## SERVICE BULLETIN

TS-930S Low RX Sensitivity

3.29.83

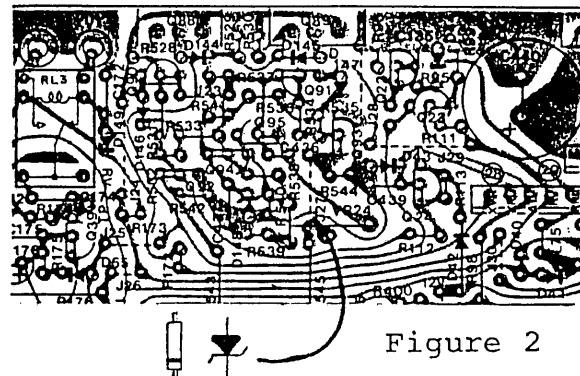
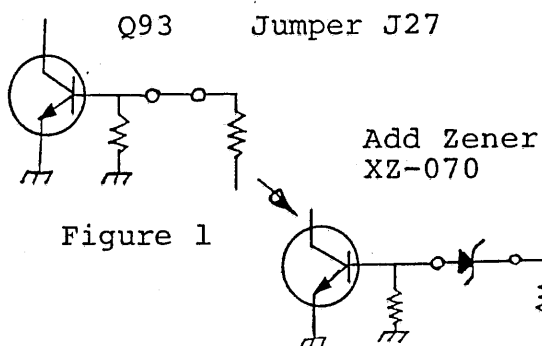
1. Replace Signal unit jumper J27 with an XZ-070 zener diode. (PCB coordinate C-1, see figure 2.)

Figure 3

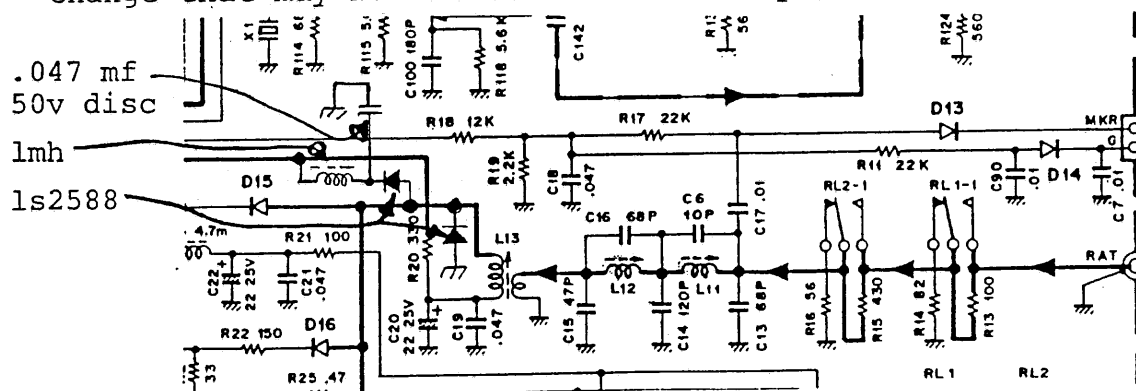
2. Change diodes D15 through D33 from BA282's to 1s2588's. Change only the defective diodes when making the repair.
3. Figure 3 shows a circuit that is capable of withstanding antenna input levels of up to 50 Watts. Use this on units that may be subject to high levels of RF. (This is an optional change that may not be done in warranty.)
